## DESIGN REVIEW BOARD RECOMMENDATION MEETING

2ND + STEWART | 1613 2ND AVENUE

DPD# 3016702 September 29, 2015

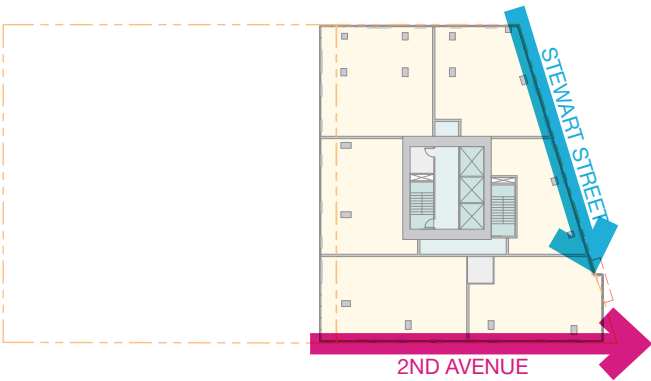
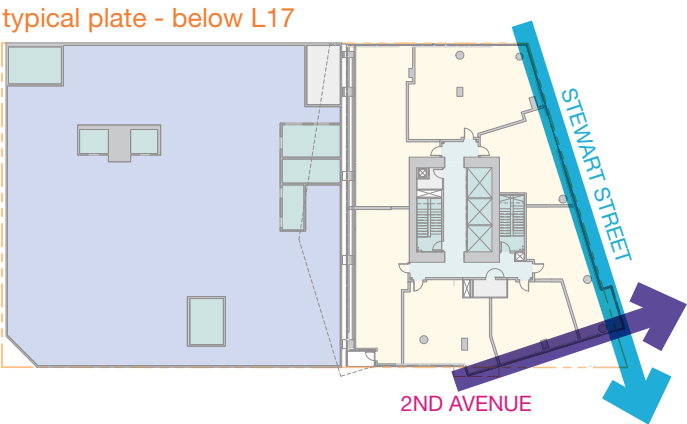
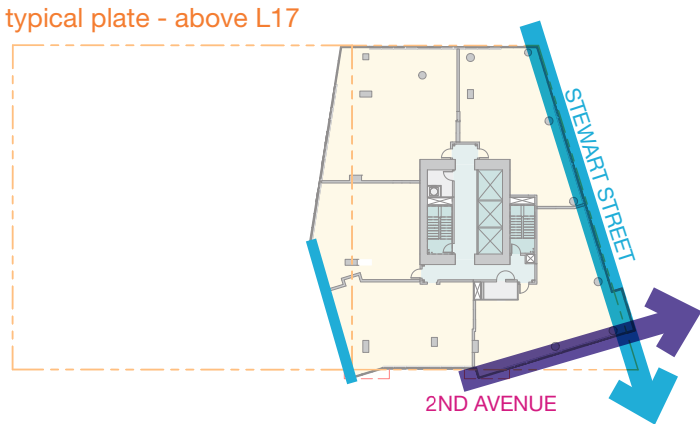
**Board's Deliberations:**  
“There was a good deal of discussion, however, and differences in feelings expressed, regarding preferences between the two new alternatives. While alternative two was thought to be a simpler, more perceptibly slender, calmer, and elegant design, one of the Board members responded more favorably to the shift and cant that occurred at the 17th floor of alternative 1. It was thought that alternative 1 deserved further study and exploration as a viable alternative, and the design team was encouraged to do that as the proposal progressed.”

**Response:**  
This DRB proposal has progressed EDG #2's alternative 1 canted massing to reflect the change in the street grid as requested by the board. The preferred ground level and above grade parking co-mingled with residential units of the EDG #2 alternative 2 has been essentially maintained with refinement based upon the Board's direction described below.

aerial view from the southwest

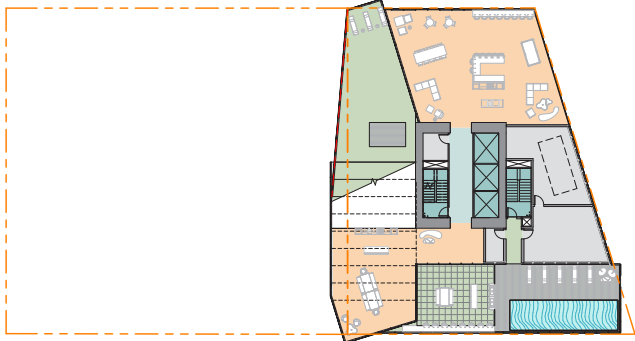
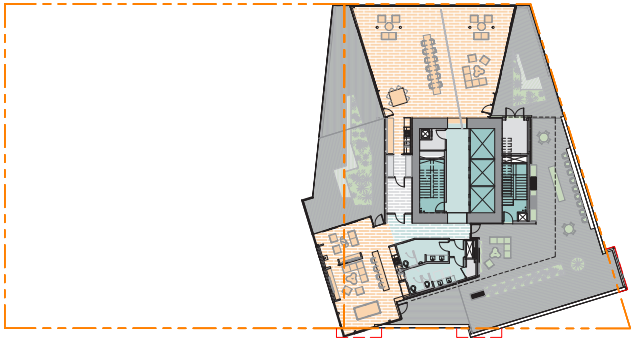
"There was a positive response to the unusual rooftop configuration, but the Board would like to see further details, and from a variety of perspectives, how it caps the building."

Two interior rooftop rooms and outdoor spaces provide outdoor common recreation area for the residents. The angular forms of the spaces are blended with the massing below to reflect the irregular street geometry.

street level view | Stewart Street + Alley

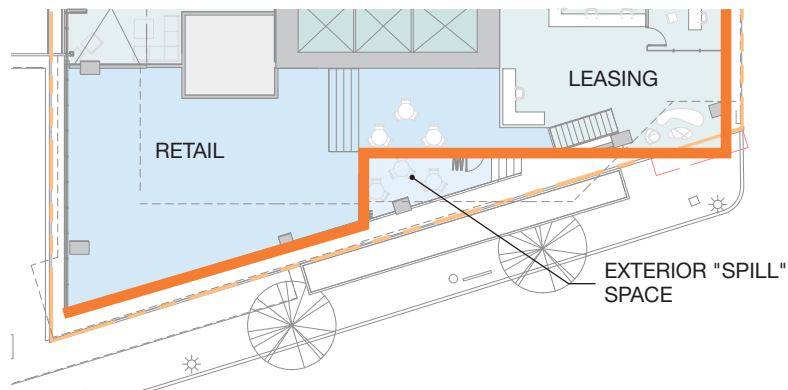
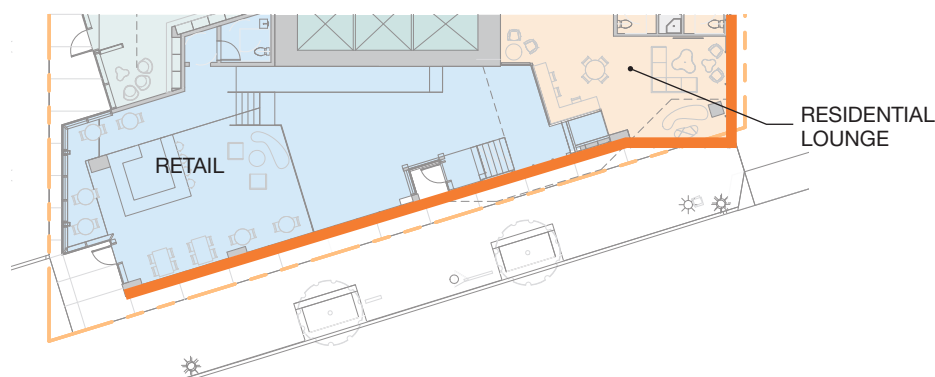
"The raised outdoor platform area accessed by stairs from Stewart Street and providing accessory space for the adjacent retail was not universally acclaimed by the Board who desired to see further demonstration of actual views down the street toward the water and demonstration of how it would be protected from wind and weather and operate as a successful outdoor retail space. Provide vignettes of the relationship to the sidewalk and how the outdoor space would work."

Please see L01 Floor Plan (page 20) and the 2nd Avenue street level perspective (page 36). Since the EDG #2 meeting the raised outdoor area has been revised to be included as interior space with a simpler storefront façade as suggested by the board. The retail space along Stewart is arranged as three stepped levels along the façade to better visually connect with the level 2 residential lounge area, creating an pedestrian friendly active façade for the length of Stewart Street.

DRB | GARAGE ACCESS, NO STREETCAR .....

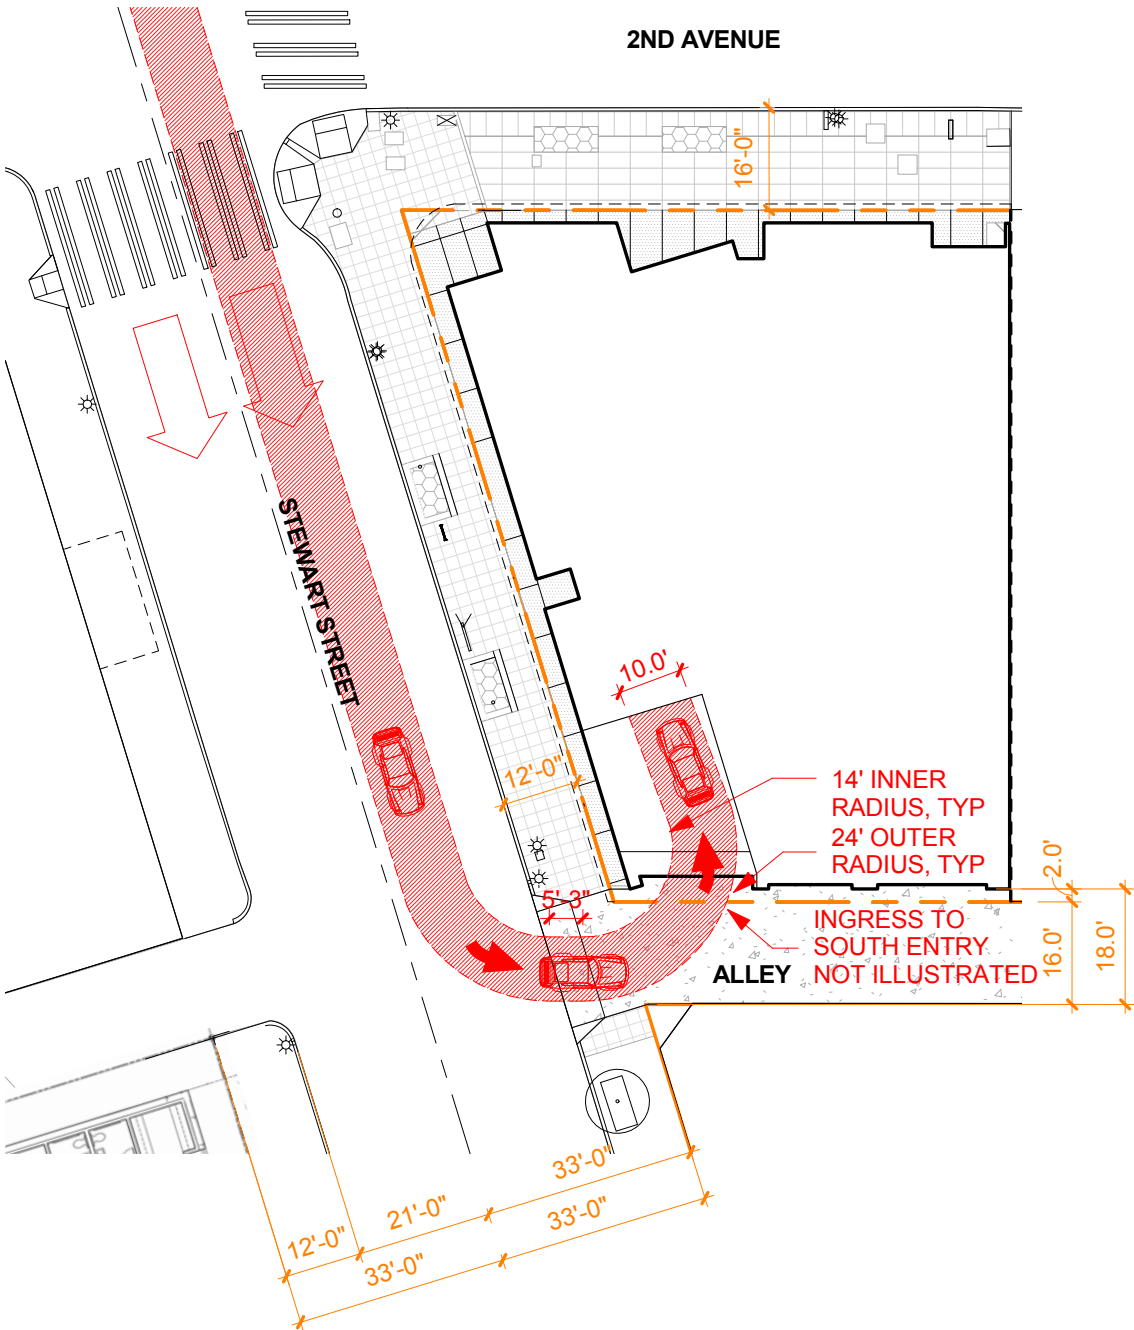
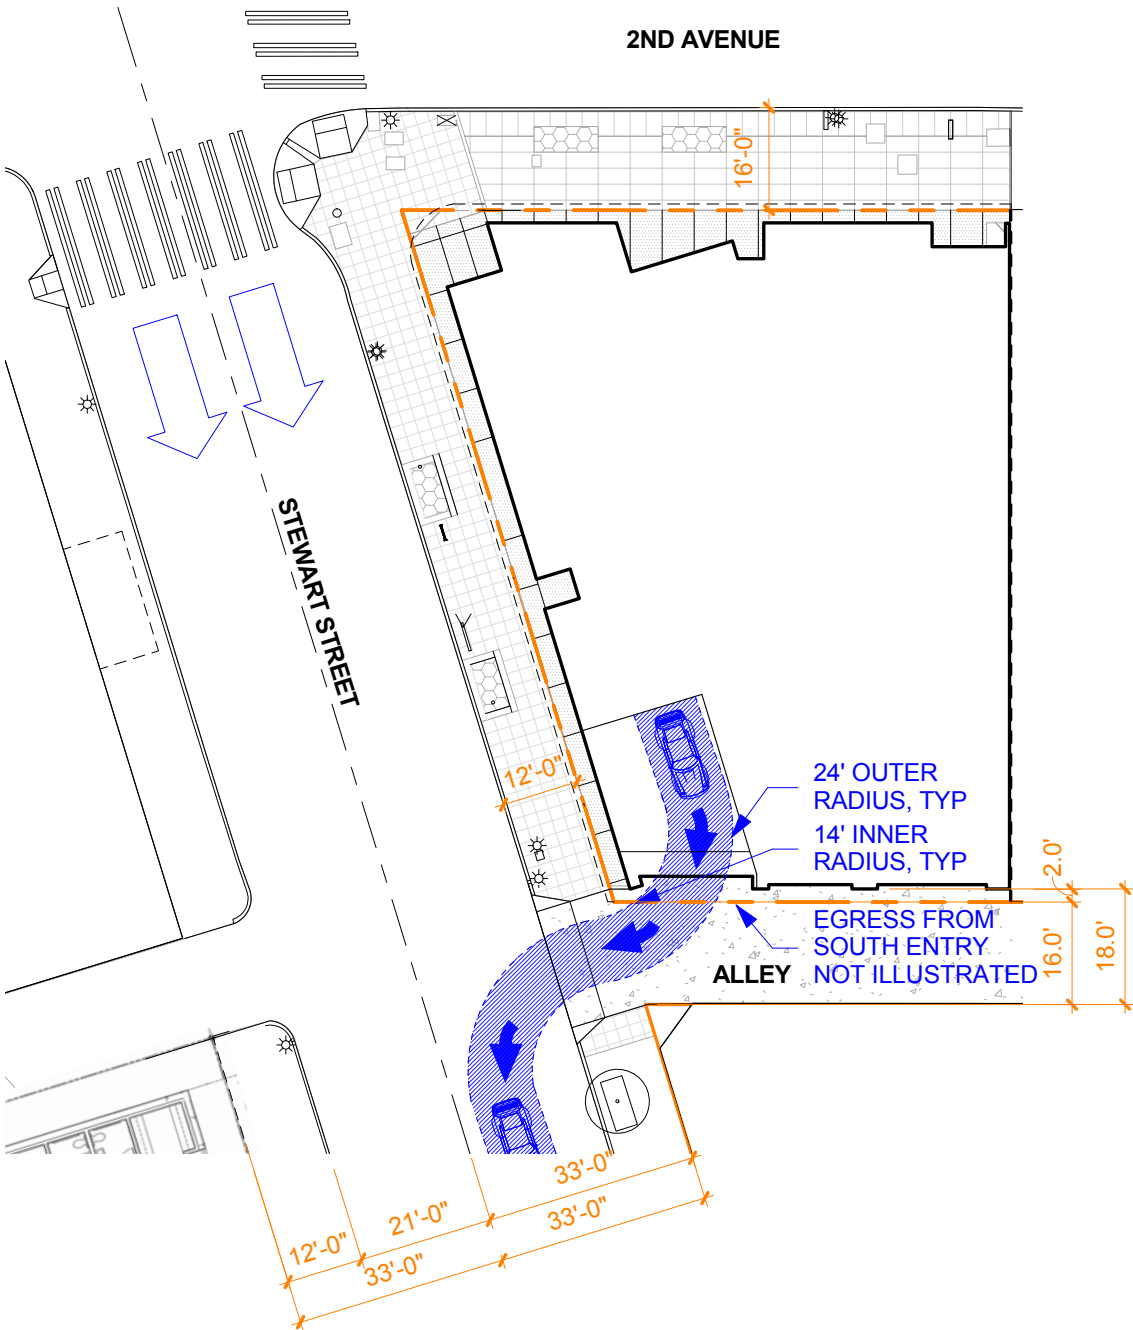
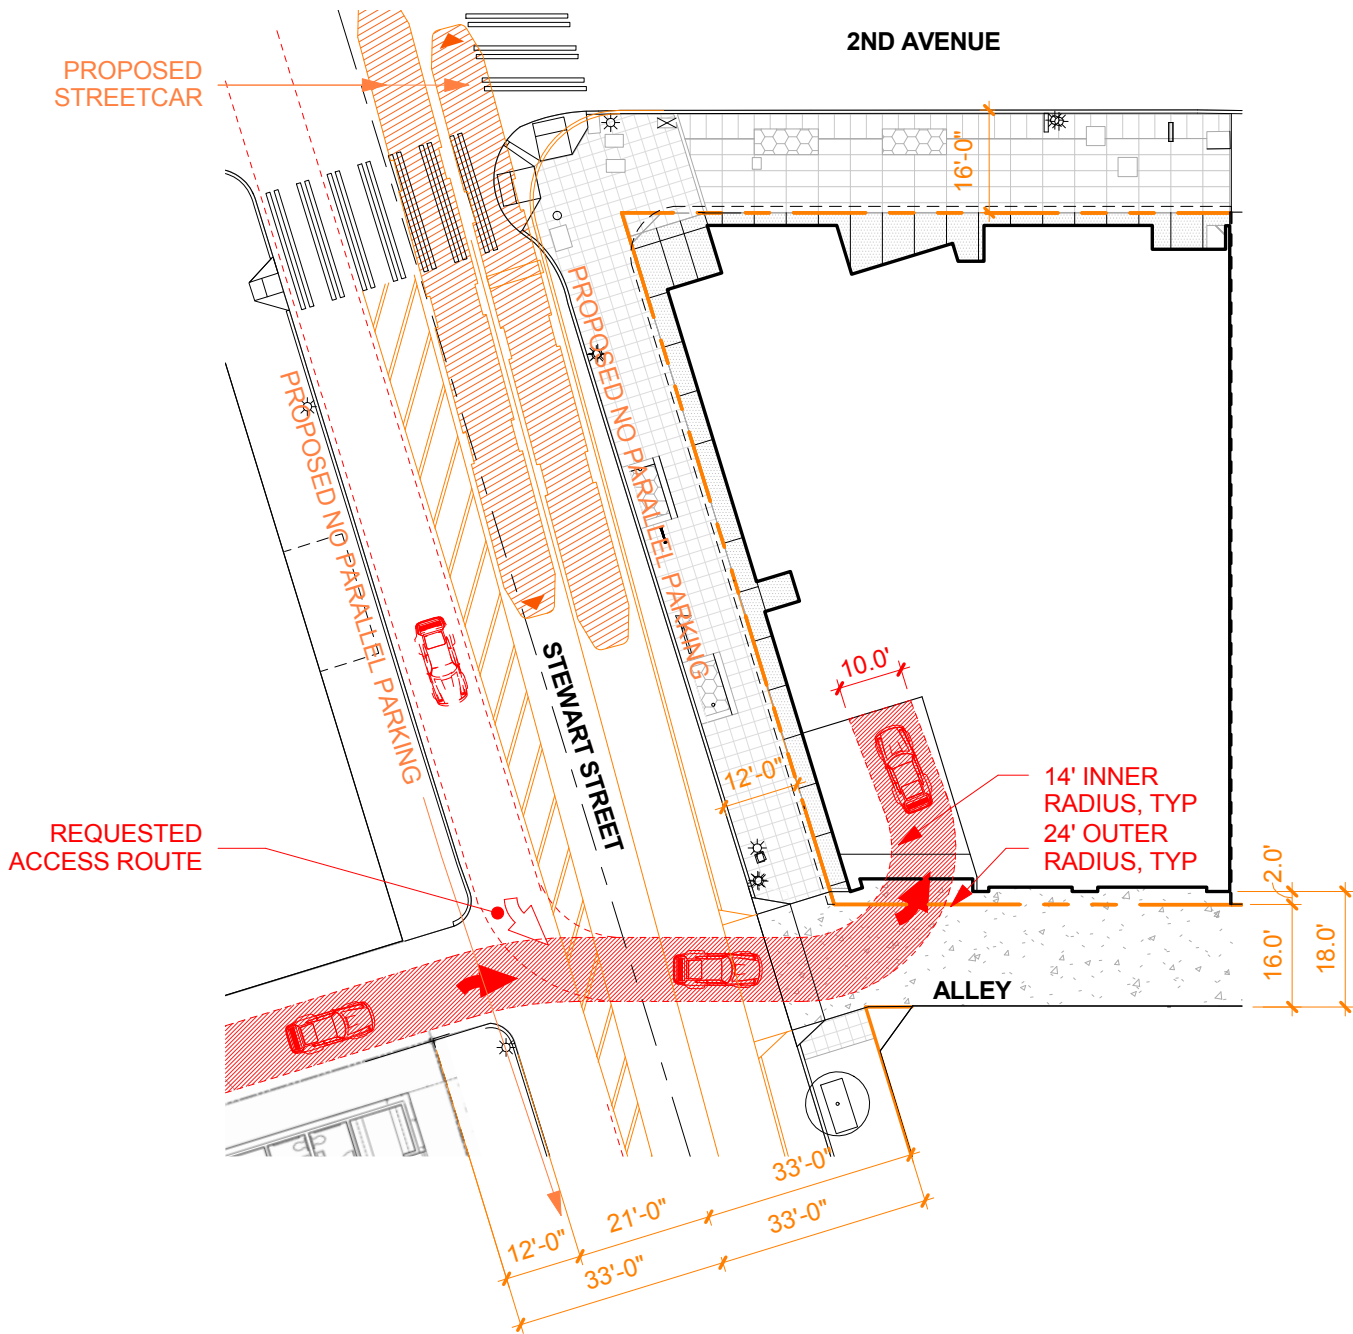
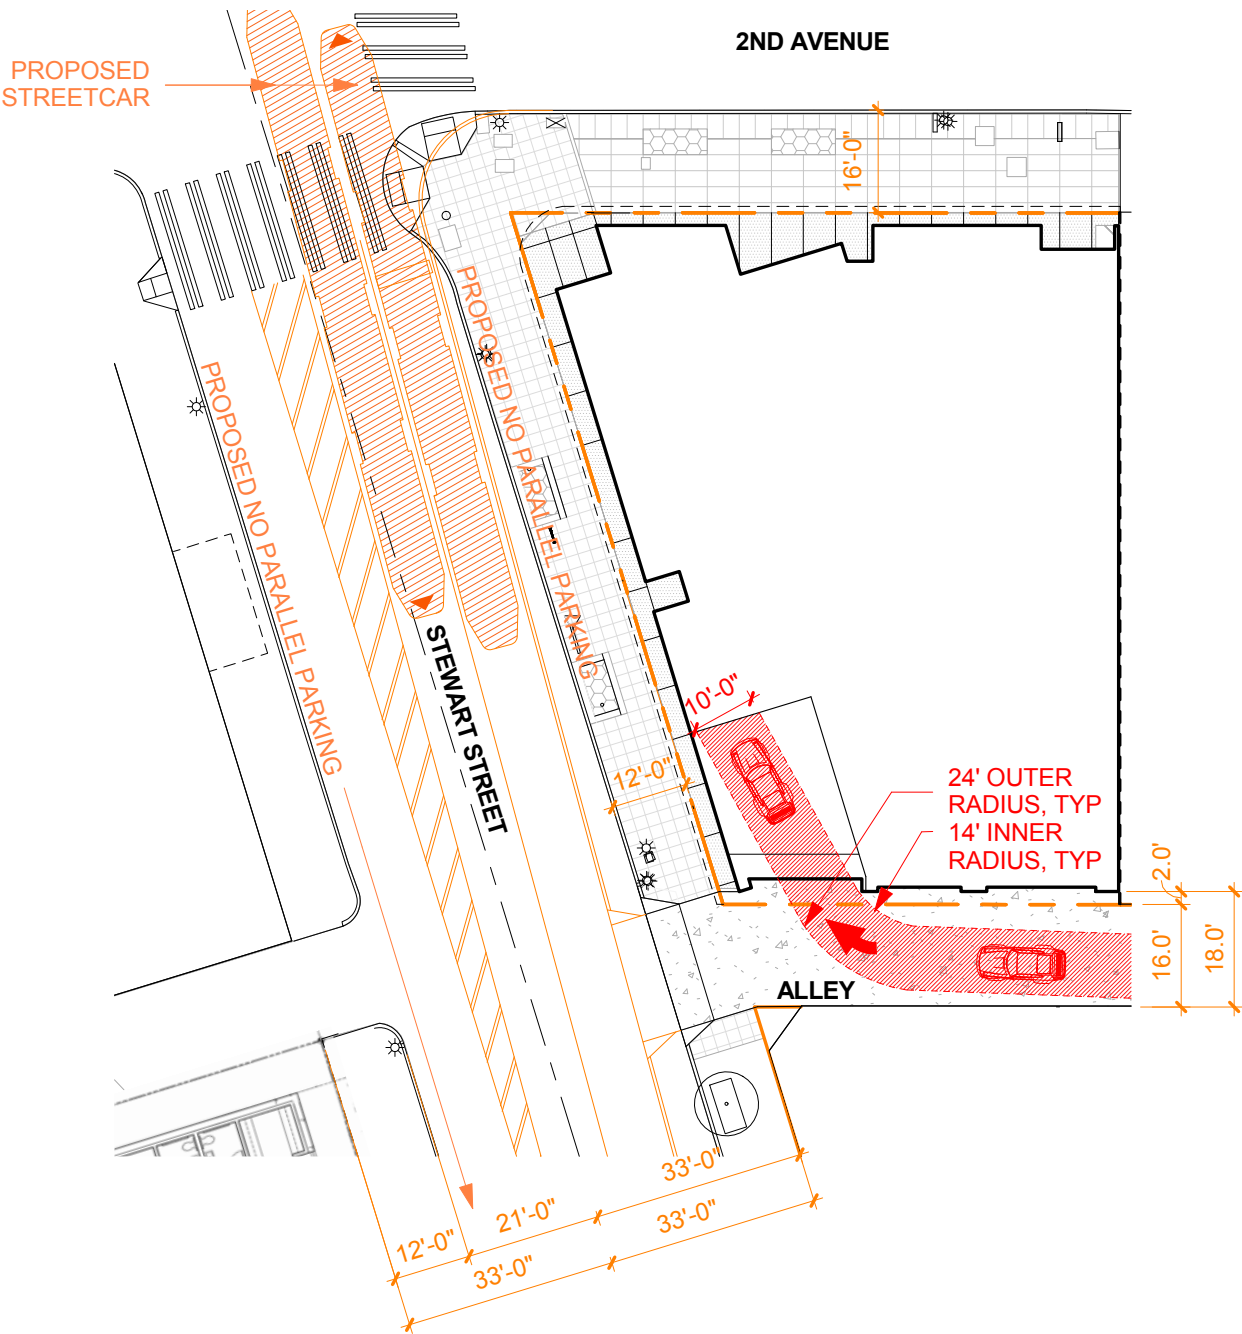
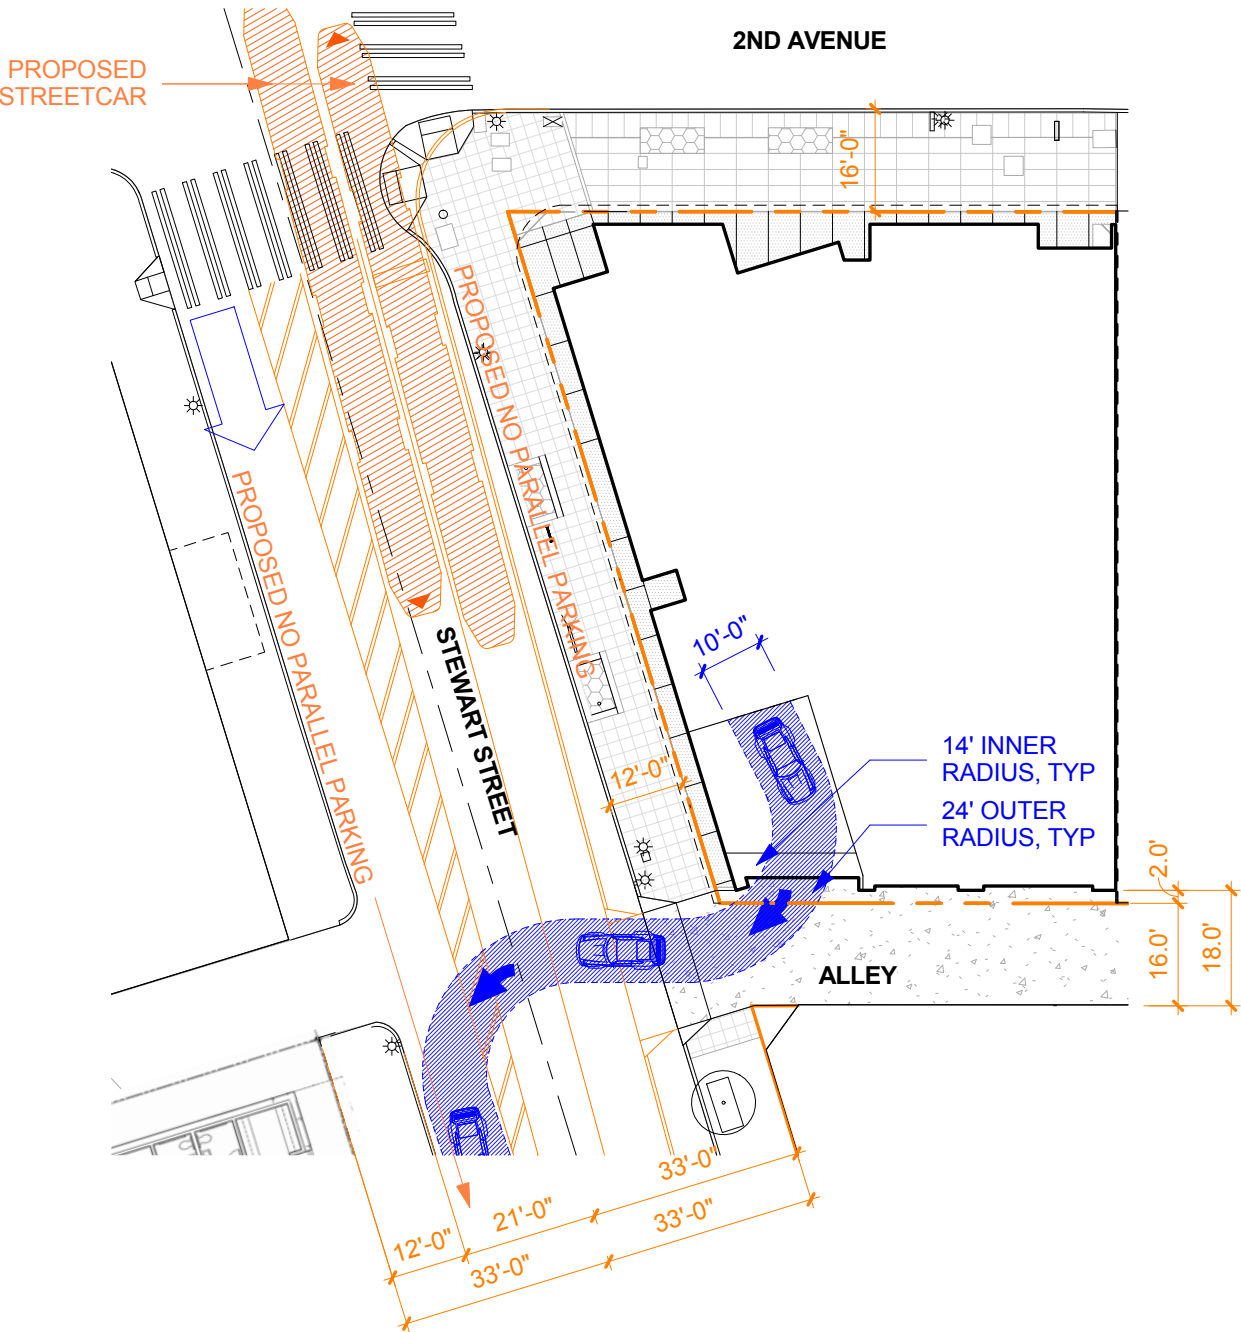
**Board's Deliberations:**  
"Demonstrate to the Board how the turning radii in and out of the parking openings would work safely and effectively."

**Response:**  
Please see turning radius diagram on the following pages for entry and exit into the northern garage in both "no street car" and "future street car" configurations.
